04 Independent Quality Assurance: Waterproof/Fix Inspection

Single storey
Slab on ground
Timber frame
Sheet roof
Brick Veneer
Rendered brickwork
Rendered lightweight cladding

Photo 17

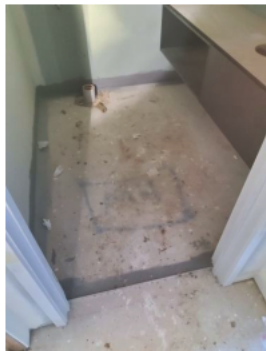
Membrane not protected:

Membrane not protected. Refer to AS 3740: Waterproofing of domestic wet areas; section 3.5 CURING OF MATERIALS:

Materials shall be cured adequately for their intended use.

NOTE: The membrane should be protected from physical and/or chemical damage until covered by the finished surfaces.

Photo 21

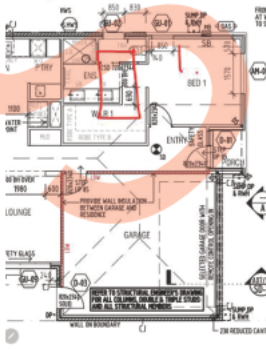
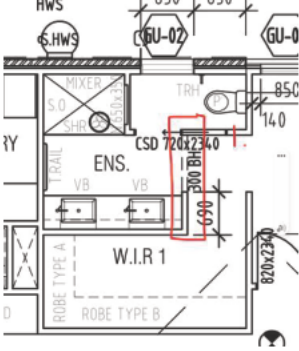
Wall positioning not as per WD A03. Bulkhead finishes above doorway, not as per Drawings.

Added reference of Lot 14 Serene as a visual reference.

FIGURE 3.4 TYPICAL DETAIL FOR RECESSED SOAP HOLDERS

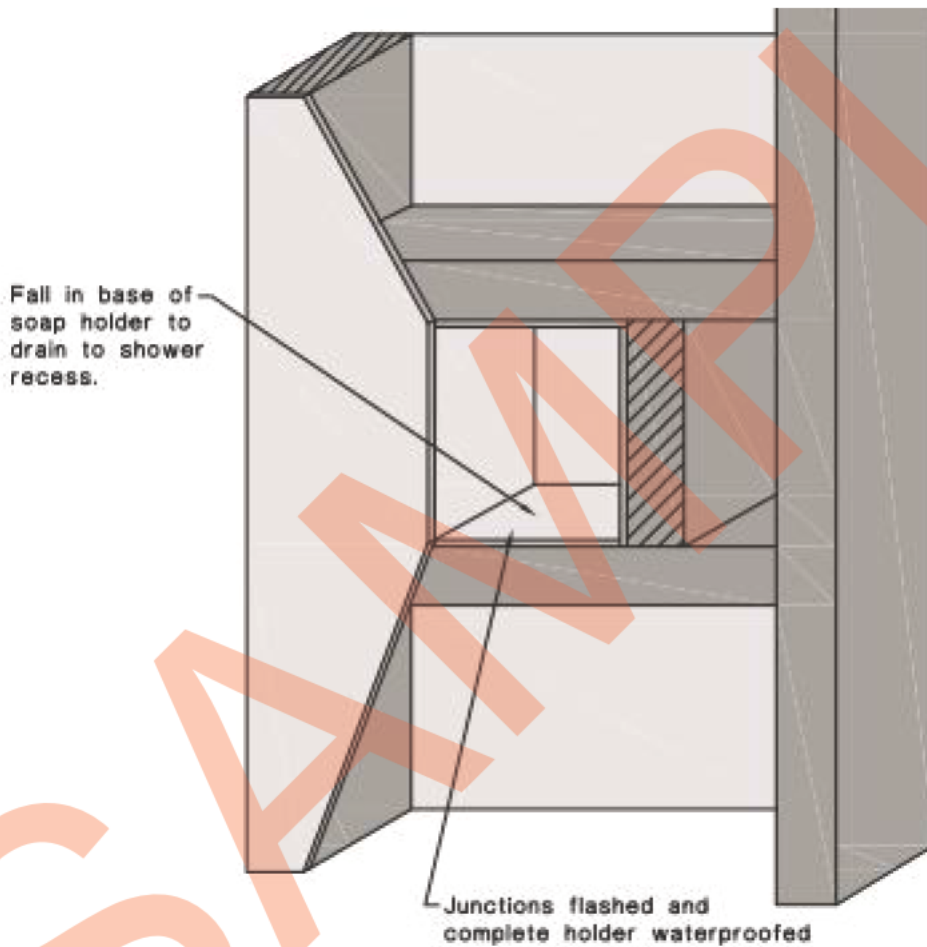
Fall in shower niche in opposite direction.

AS 3740-2010 Figure 3.4 Typical detail for recessed soap holders requires fall to the base

Figure 4.9.1(A) — Example of liquid waterproofing at door opening framework

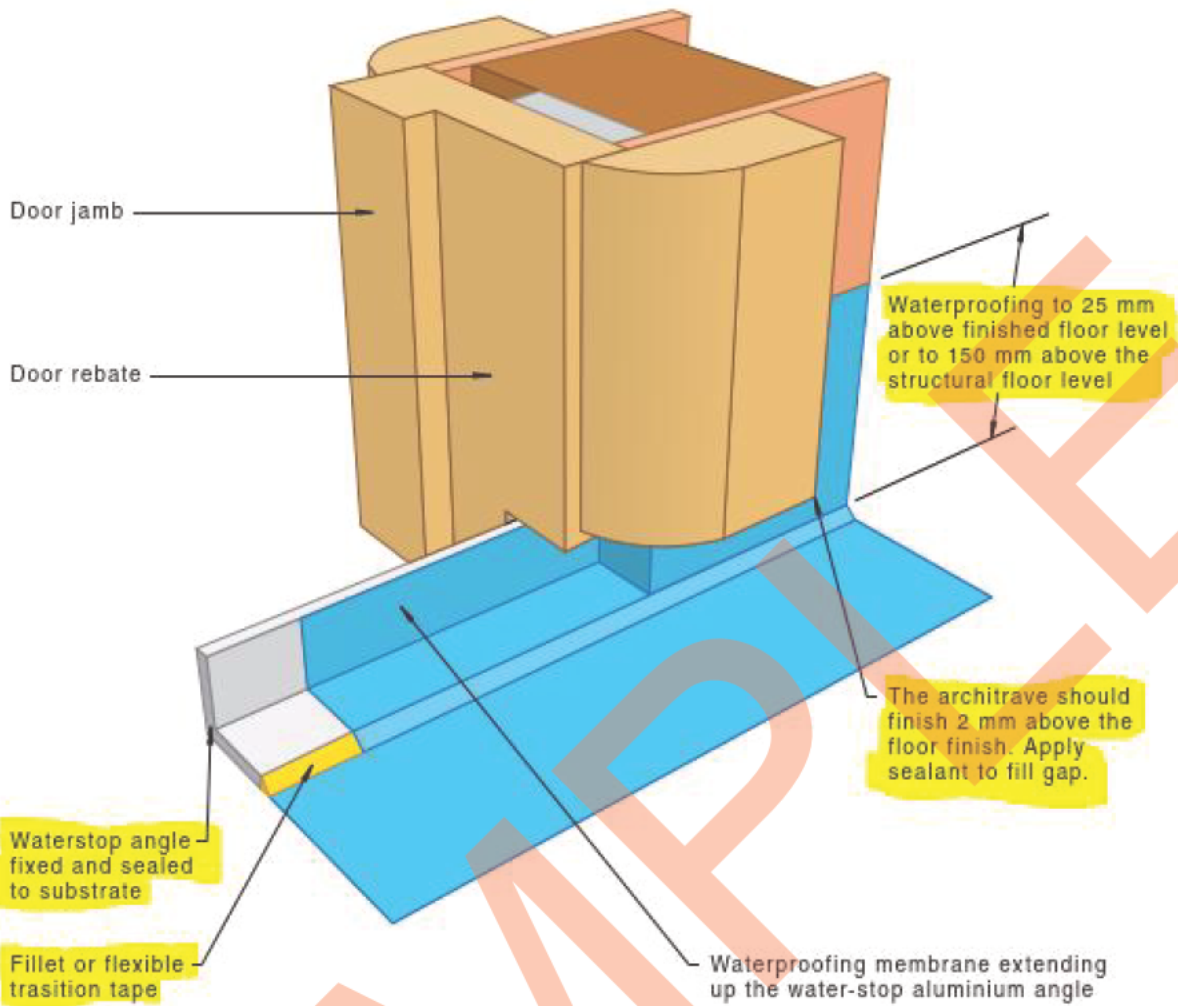
Waterstop significantly gapped. Waterstop performance solution required.

A waterstop is required to be installed at floor level openings as per AS 3740:2021-Waterproofing of domestic wet areas section 4.9.1: Perimeter flashing at floor level openings:

FIGURE 3.4 TYPICAL DETAIL FOR RECESSED SOAP HOLDERS

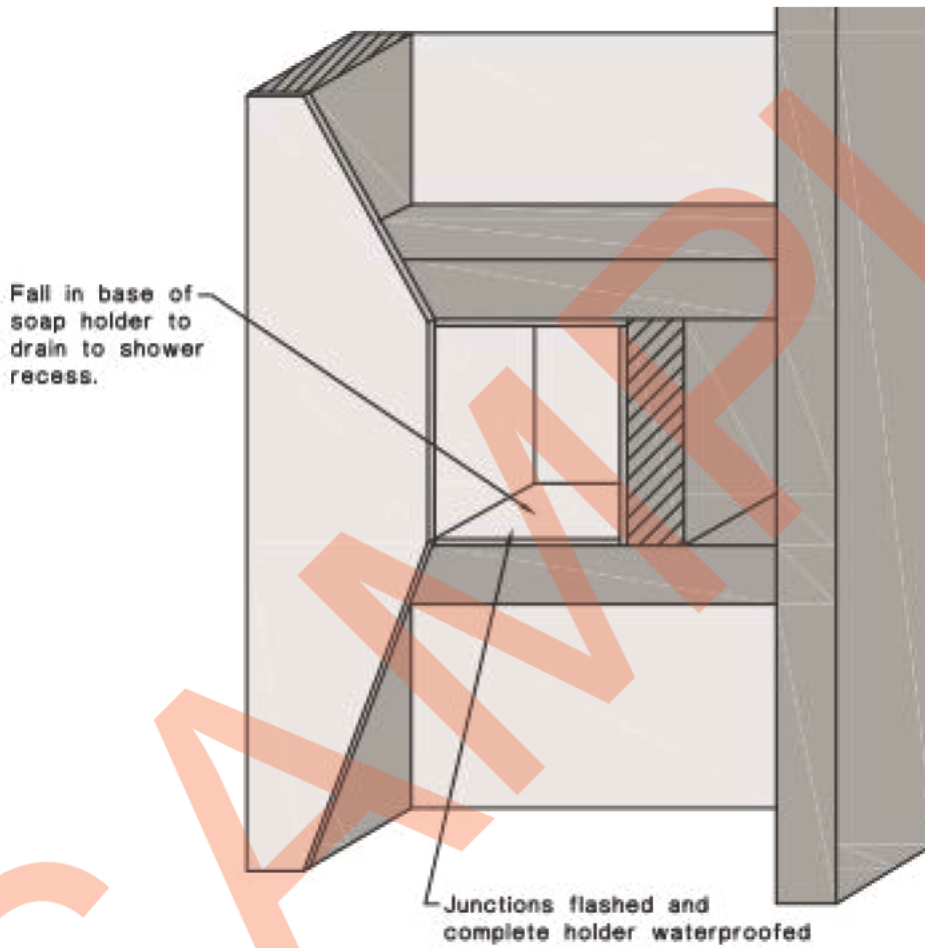
No fall to base.

AS 3740-2010 Figure 3.4 Typical detail for recessed soap holders requires fall to the base

Photo 44

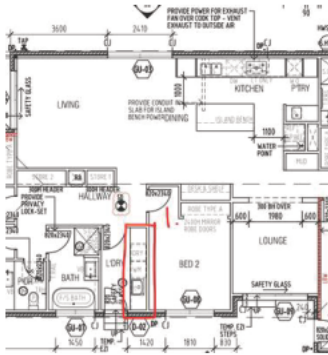
Junctions underneath joinery not sealed/waterproofed prior to cabinetry installation.

The Building Code of Australia Volume Two Part 3.8.1.2 Wet Areas states "Building elements in wet areas within a building must— (a) be waterproof or water resistant in accordance with Table 3.8.1.1 ; and (b) comply with AS 3740." Table 3.8.1.1 requires wall and floor junctions to be "water resistant"

Photo 49

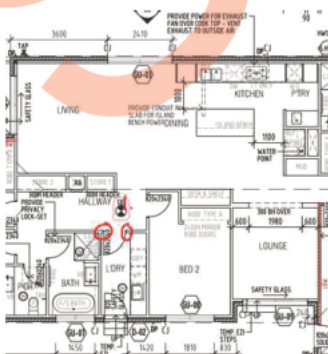
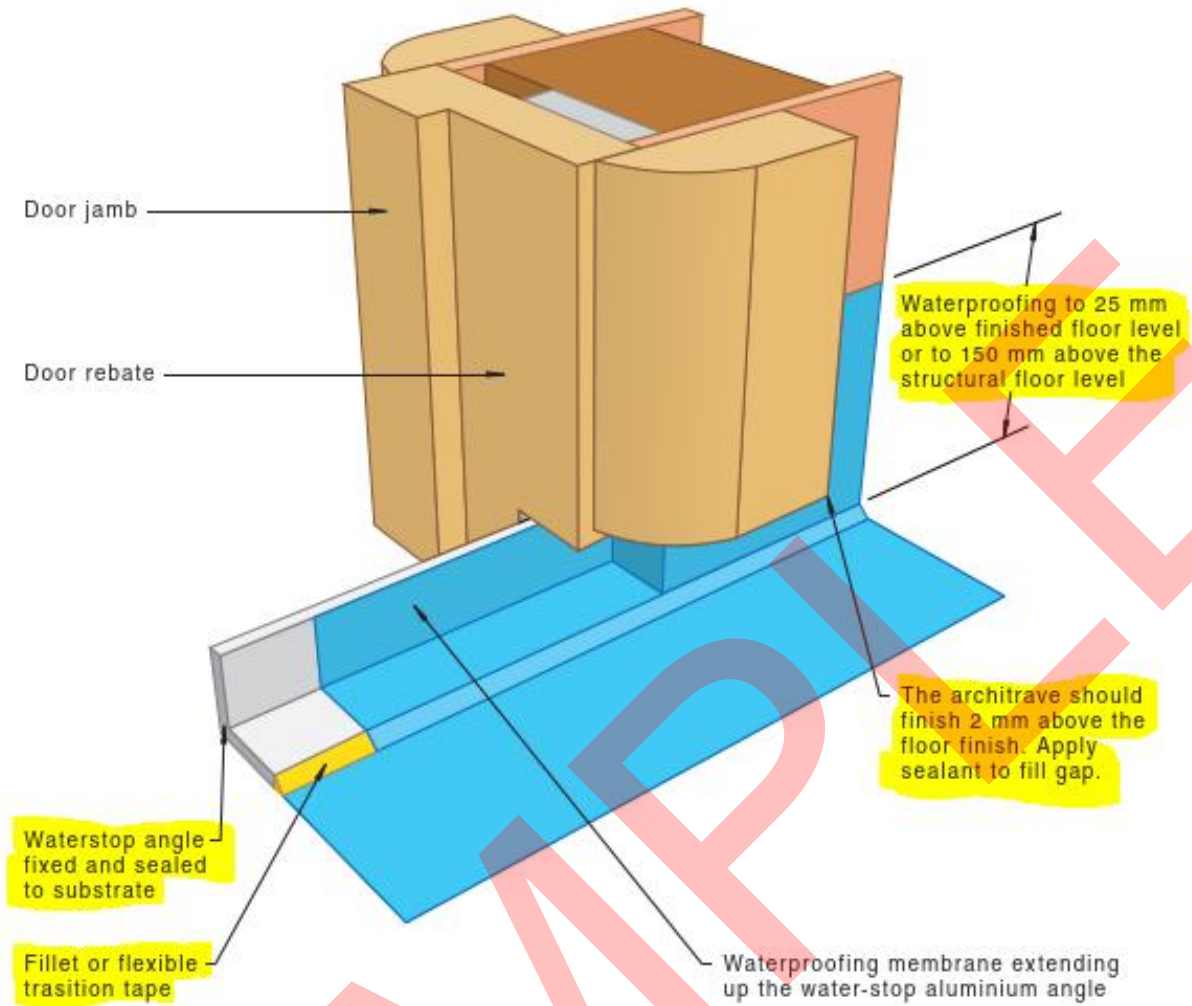
Waterstop not continuous & door architrave flush with the floor.

A waterstop is required to be installed at floor level openings as per AS 3740:2021-Waterproofing of domestic wet areas section 4.9.1: Perimeter flashing at floor level openings:

Photo 53

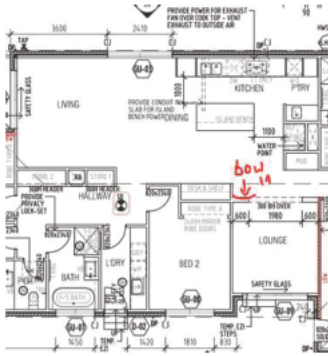
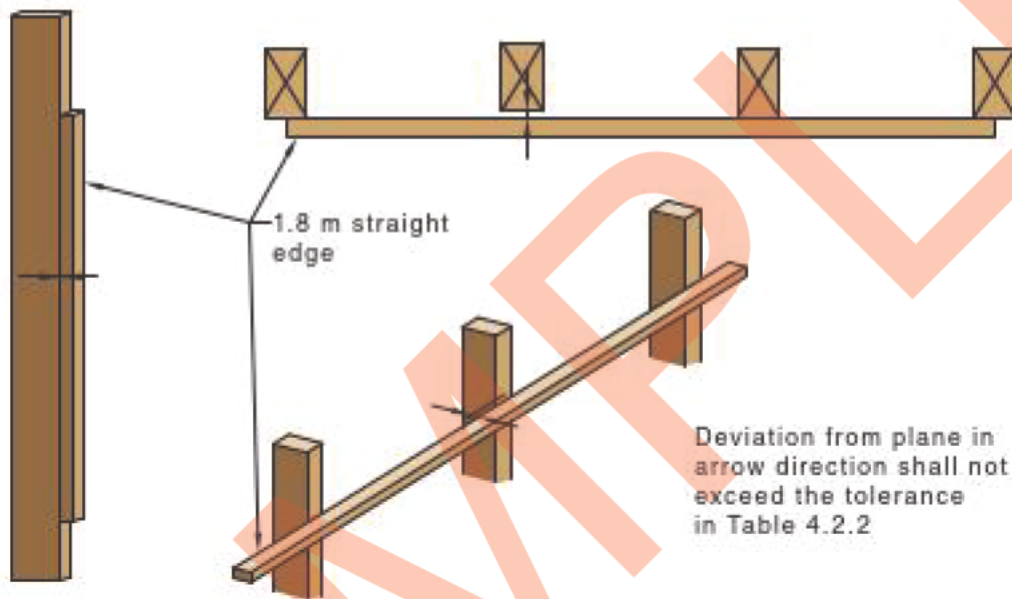
9.1: No visible bows at external corners

As per Australian Standard 2589: Gypsum linings—Application and finishing, section 4.2.2 Finished framing deviations and tolerances:

“The deviation in the position of the bearing surface of the finished framing immediately prior to installation of lining from a 1.8 m straight edge shall not exceed the values given in Table 4.2.2 when measured over a 1.8 m span at any point [see Figure 4.2.2(A)].”

Photo 54

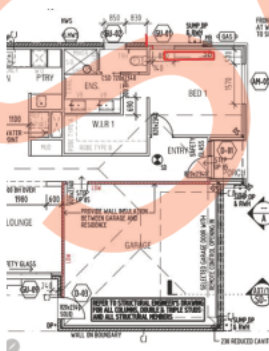
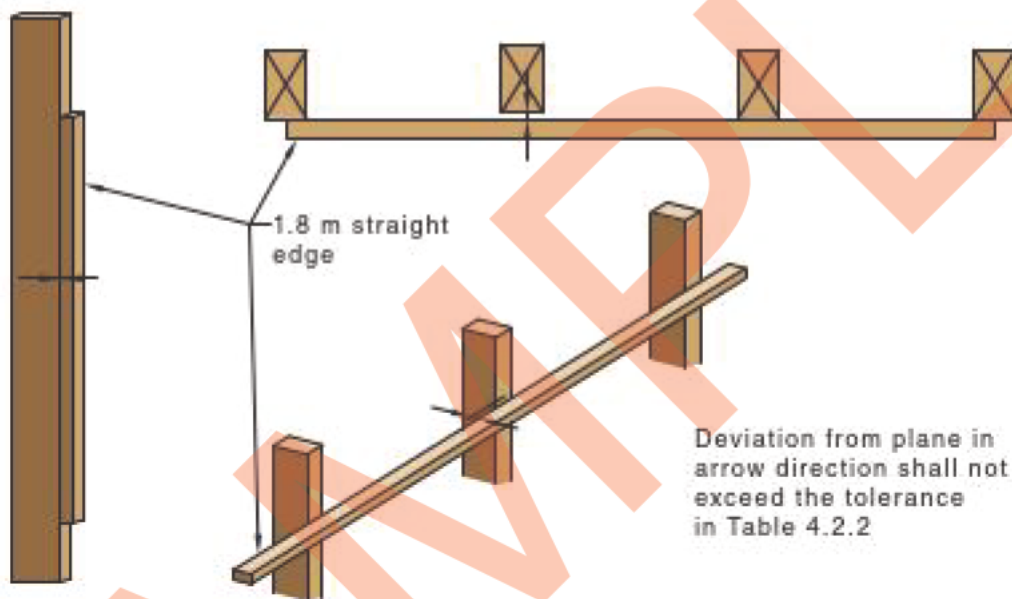
Large 30mm bow in ceiling/cornice. Refer to Pre-plaster Inspection report which shows sump dropping below ceiling line.

As per Australian Standard 2589: Gypsum linings—Application and finishing, section 4.2.2 Finished framing deviations and tolerances:

Photo 57

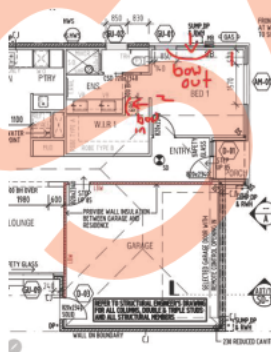
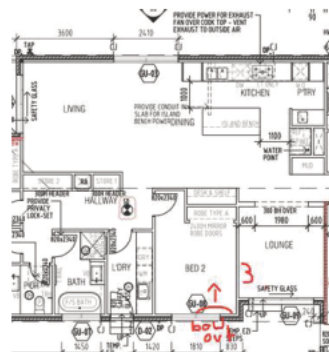
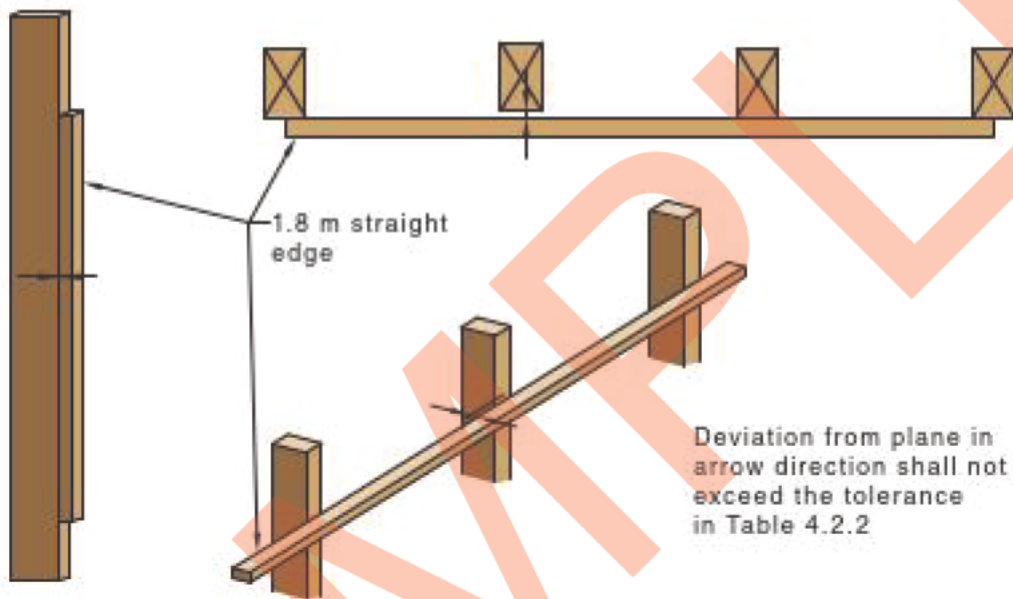
+9.3: Visible bulge/lump/bump in plaster

As per Australian Standard 2589: Gypsum linings—Application and finishing, section 4.2.2 Finished framing deviations and tolerances:

Photo 59

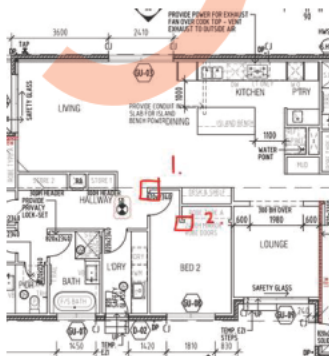
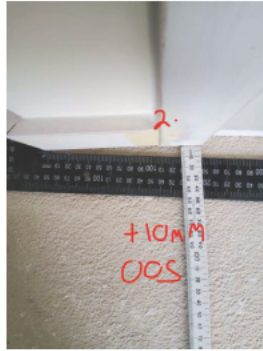
Corner out of square. Refer to AS1684.4-2010, Figure 4.2.2. Image below.
